Snowland Subdivision 2025; KPB File 2025-019
 Peninsula Surveying / Trident Investment Properties LLC
 Location: Glenwood Avenue, Milkyway Street – off Holt
 Lamplight Road
 Nikiski Area / Nikiski APC

ITEM #6 - PRELIMINARY PLAT SNOWLAND ESTATES 2025

KPB File No.	2025-019
Plat Committee Meeting:	March 24, 2024
Applicant / Owner:	Trident Investment Properties, LLC
Surveyor:	Jason Schollenberg / Peninsula Surveying, LLC
General Location:	LOCATION / APC

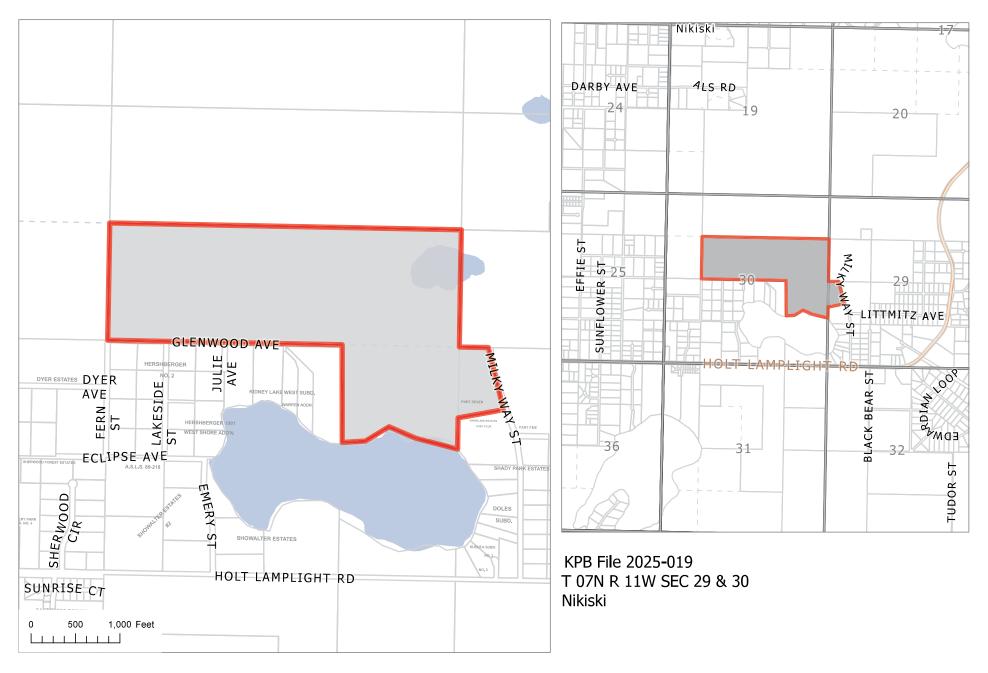
- Show a detail in the southwest corner of Tract C1 to better detail what is going on there.
- Signatory will need to be added when determined to the Certificate of Ownership an Dedication and to the Notary Acknowledgement.

Check the total acreage, staff gets 158.055 acres.

Easements are listed in the certificate to plat that affect this property and should be noted on the plat.

There are low wet areas that need added to the plat or revised, the pond has depression expanded past its shoreline. The lake on the south has wetlands also.

Wetlands

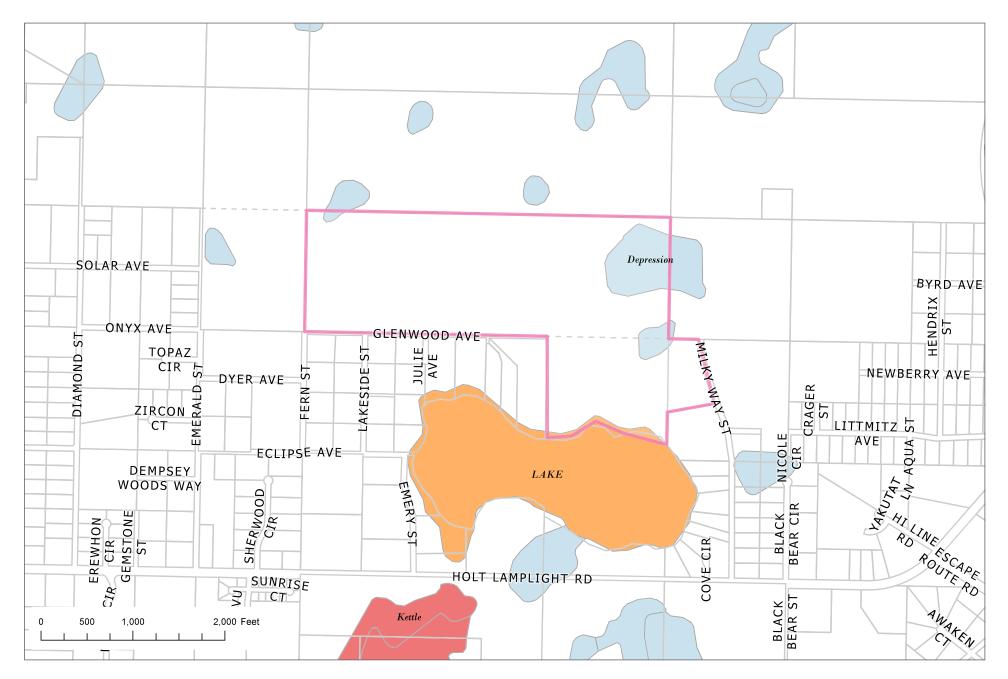
The River Center review did not identify the plat to be located in a FEMA designated flood hazard zone or a habitat protection district. Per the KWF Wetlands Assessment there are wetlands located on the plat. The wetlands assessment identifies the pond as 'depression' and Kidney Lake as 'lake' going onto land slightly. **Staff recommends** the drawing should be adjusted to show both designations and the lake edging per the wetlands assessment. **Staff recommendation**: the note as follows be added to the plat any person developing the property is responsible for obtaining all required local, state, and federal permits, including a U.S. Army Corps of Engineers wetland determination if applicable.
